REFERENCE:	Nova Bus Manuals
SECTION:	16 Electrical system
RS N°:	MQR 7621-533
EFFECTIVE IN PROD.:	L681-70

SUBJECT:	Next Stop wiring harness.
JUSTIFICATION:	Protective sheath of the Next Stop wiring harness could become stripped by the sharp edges of the pass-through hole.

Figure 1 - Next Stop Wire Passing Through the Structural Ceiling Beam

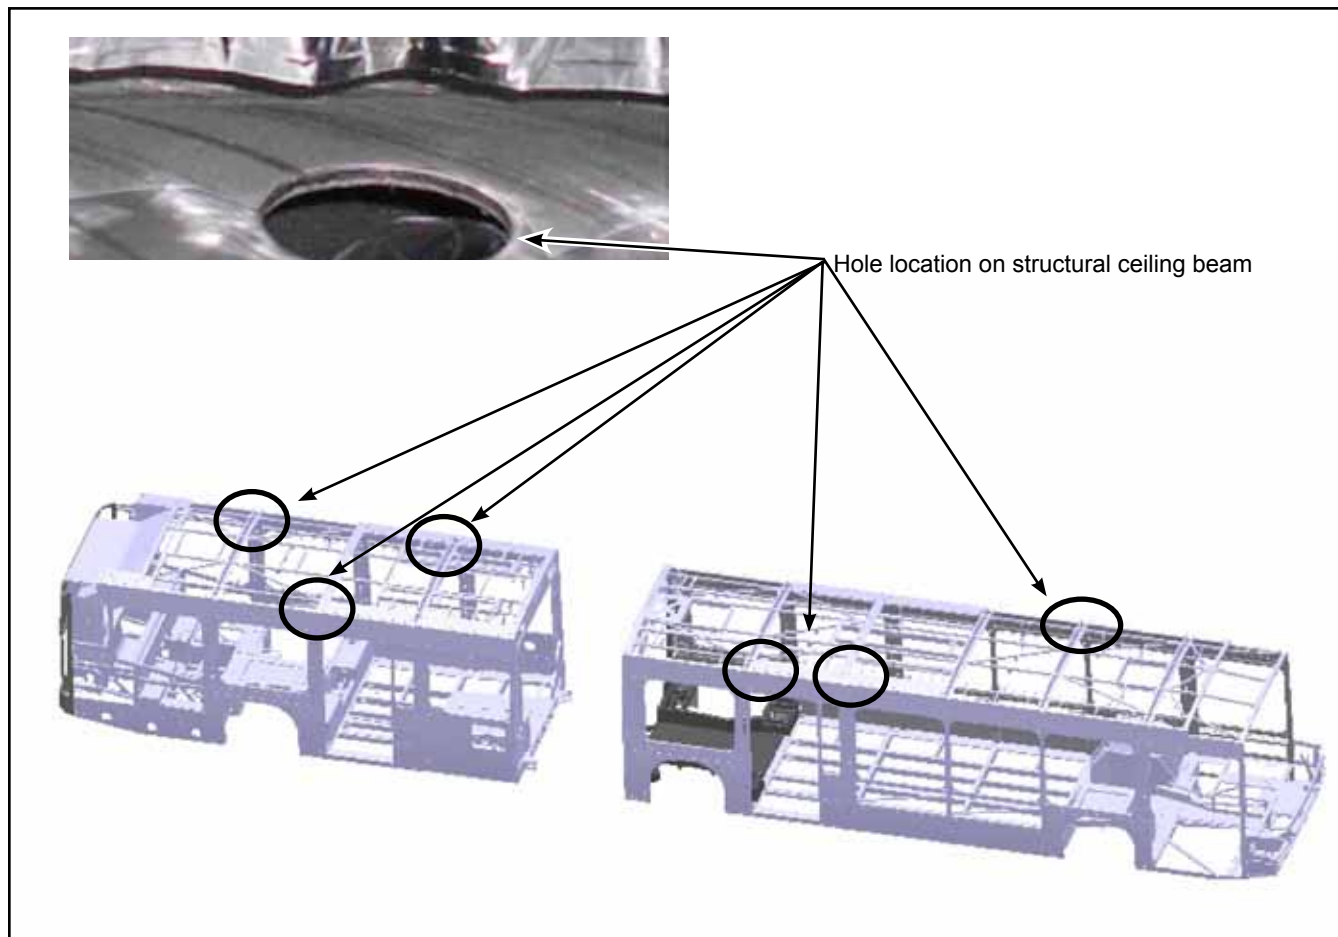
- 1.1. Inside the vehicle, open the corresponding baselights.
- 1.2. Locate the wires passing through the structural ceiling beam hole. See Figure 1.

- 1.3. Install the open/close plastic bushing G5008610 into the hole as shown in Figure 2.

- 1.4. If wires are stripped, wrap electrical insulating tape around the stripped wires.
1.5. If the wires are not stripped, close the baselights.
1.6. The vehicle can be returned to service.❖
